> Nine Mile Point Nuclear Station, Unit 1 Renewed Facility Operating License No. DPR-63 NRC Docket No. 50-220

- Subject: Response to Request for Additional Information by the Office of Nuclear Reactor Regulation to Support Review of Nine Mile Point Nuclear Station, Unit 1, License Amendment Request to Apply TSTF-542, Revision 2, Reactor Pressure Vessel Water Inventory Control
- References: 1. Letter from J. Barstow (Exelon Generation Company, LLC) to U.S. Nuclear Regulatory Commission, "License Amendment Request-Revise Technical Specifications to Apply TSTF-542, 'Reactor Pressure Vessel Water Inventory Control,' Revision 2," dated December 15, 2017
 - Email from M. Marshall (Senior Project Manager, U.S Nuclear Regulatory Commission) to R. Reynolds (Exelon), "Nine Mile Point, Unit 1-Request for Additional Information Regarding Reactor Pressure Vessel Water Inventory Control License Amendment request (L-2017-LLA-0426)," dated August 15, 2018

Response to Request for Additional Information

TABLE 3.6.2d

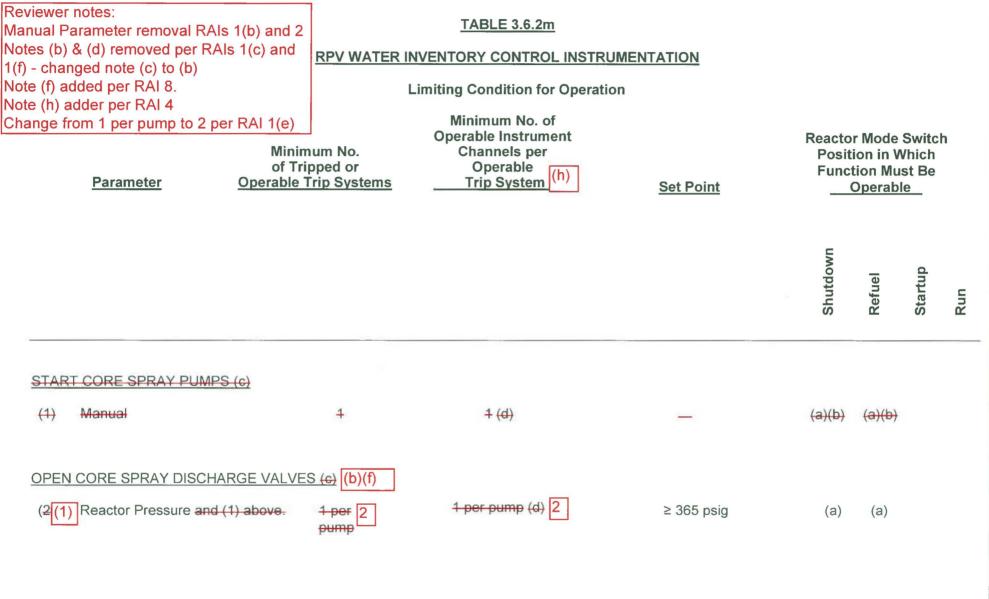
Clarify whether the applicability in the refuel position of the mode switch is or is not being removed from Proposed TS Mark-Up Table 3.6.2d.

The NMP1 design requires the mode switch to be in the "Refuel" position to withdraw control rods for scram time testing during the Reactor Pressure Vessel pressure testing. The Reactor Manual Control System is de-energized when the mode switch is in the "Shutdown" position. The applicability of these parameters is modified with note (h) added to page 219 stating the parameters are required when Reactor Coolant Temperature is greater than 212 degrees F. A reference to Note (h) is added to Table 3.6.2d under the Reactor Mode Switch "Refuel" position for the three parameters listed on page 217. The marked-up Table 3.6.2d (page 217) and Notes for Tables 3.6.2d and 4.6.2d (page 219) are included in Attachment 2.
